UNITED STATES PATENT AND TRADEMARK OFFICE

10/591,069

Johann Doppstadt

DETAILED ACTION

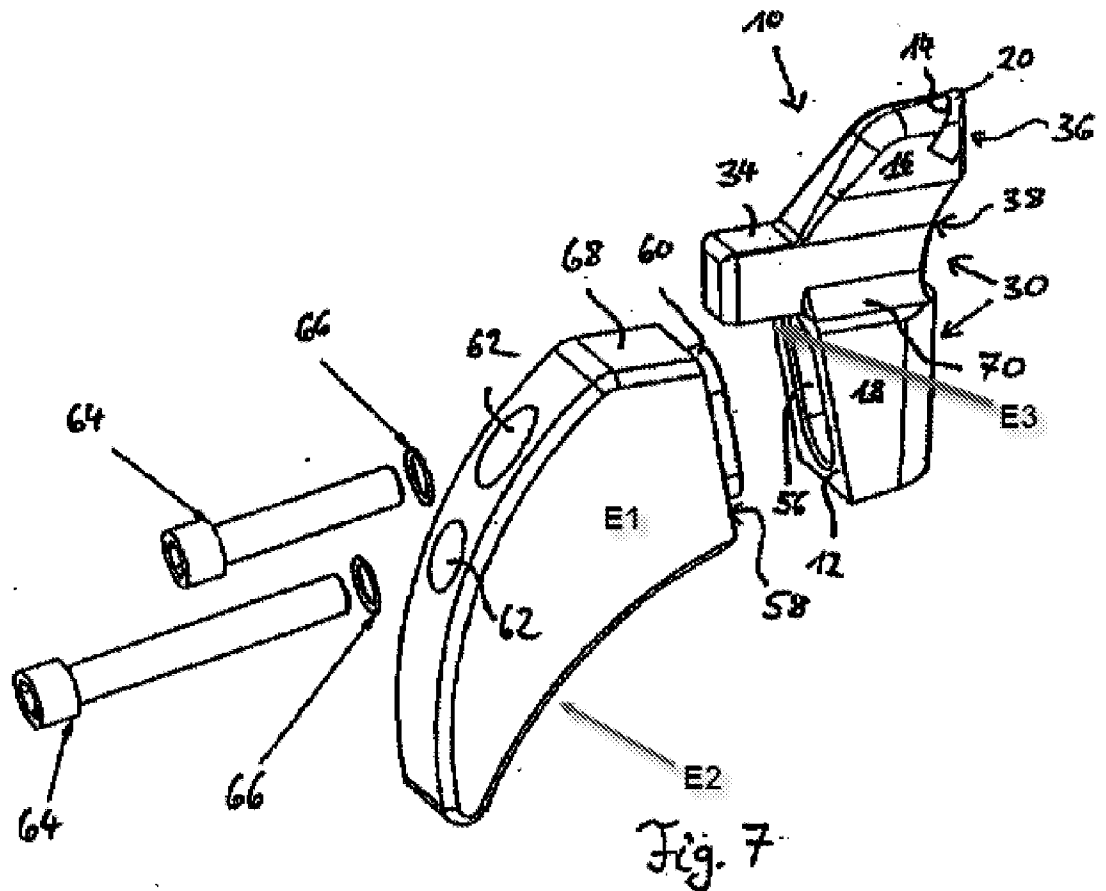
Concerning claim 31, *Pizzuto* discloses, in figure 7 below, a knife holder comprising a tooth body (E1) which is capable of being fastened on a cylinder due to its shape and a knife body (10) which is able to be attached to the tooth body in a positive locking manner through the knife receiving device (60) which is a recess which is wedge shaped. *Pizzuto* does not disclose the receiving device having a J shape.

Concerning claim 34, *Pizzuto* discloses the tooth body (E1) supports the knife flange sides (12 and 58) and an elevation (60). The further limitations are alternative structural limitation and thus not necessary for rejection purposes.

Concerning claim 35, *Pizzuto* discloses in figure 7 the tooth body (E1) and the knife (18) have shapes which correspond. The further limitations are alternative structural limitation and thus not necessary for rejection purposes.

Concerning claim 36, *Pizzuto* discloses in figure 7 the tooth body (E1) has on its bottom surface (E2) a centering device which is the curved part of the bottom surface which centers the holder on the commutation cylinder. The further limitations are alternative structural limitation and thus not necessary for rejection purposes.

Concerning claim 39, *Pizzuto* discloses in figure 7 the outer radius of the tooth body cuts on its side opposite the knife receiving device (60) which is also the outside radius of the comminuting cylinder. The further limitations are alternative structural limitation and thus not necessary for rejection purposes.

Concerning claim 41, *Pizzuto* discloses the tooth (18), which is wider than the tooth body (E1) has a support region (56) which is supported by the supporting body of the tooth body (60) and the support surfaces (50 and 58) run conically and are wedge like.

Concerning claim 43, while *Pizzuto* does not disclose two surfaces of the knife facing the tooth body and oriented downward to the recess, the combination of *Pizzuto*'s tooth body with a J shaped recess disclosed by *Galai* in claim 31 would have to have had this structure in so that the knife could mate with the tooth body.

Concerning claim 44, while *Pizzuto* does disclose the surface facing the tooth body oriented downward (68) which are recess counter faces which corresponds with the knife, *Pizzuto* does not disclose that this surface is inclined. However it would have been obvious to a person of ordinary skill in the art at the time of the invention to make this surface have an incline since there are only a few ways to mate the knife and the tooth body and thus it would have been obvious to try.
